No. 213

Investigation of Potential Geologic Hazards near the Thistle Landslide, Utah County, Utah

Grant C. Willis

Utah Geological and Mineral Survey
February, 1987

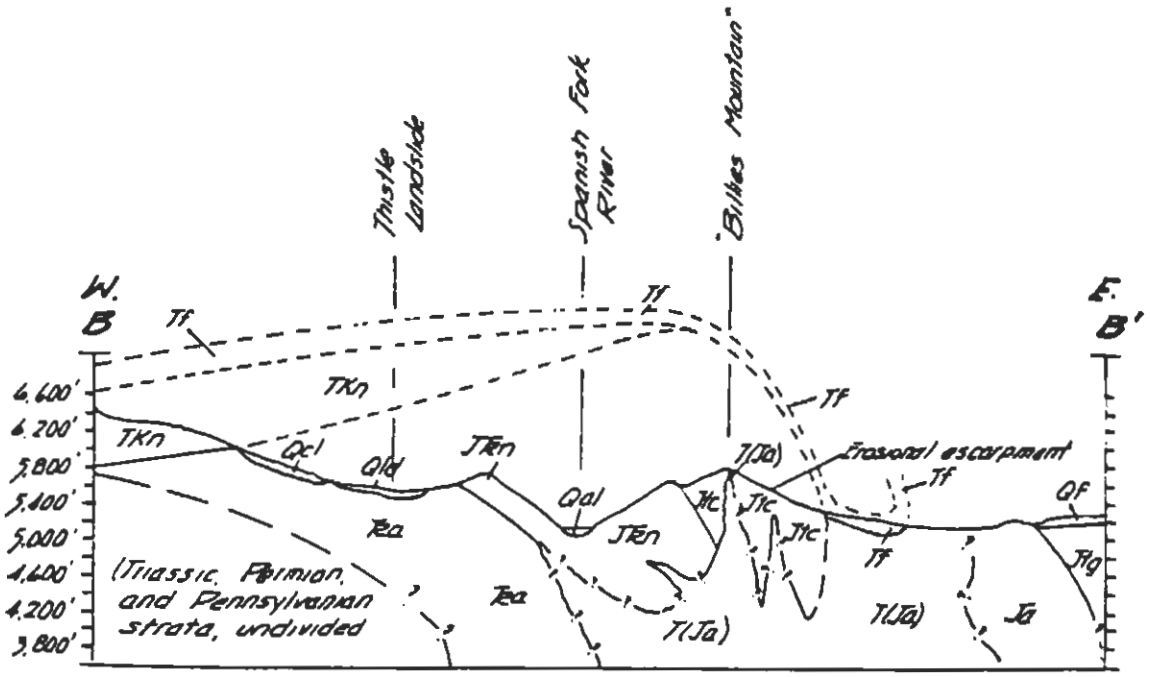
A significant difference exists between Witkind's cross sections A-A' and B-B' although they occur along strike from each other and are only about 3 miles (5 km) apart (see figure 11). In A-A' he shows a large fold in the Navajo Sandstone so that bedding between the Navajo and the North Horn becomes parallel in the west part of the section. In B-B' he does not show a fold so that the Navajo and adjacent beds are truncated at a high angle by the North Horn Formation. I believe the surface evidence supports B-B'.
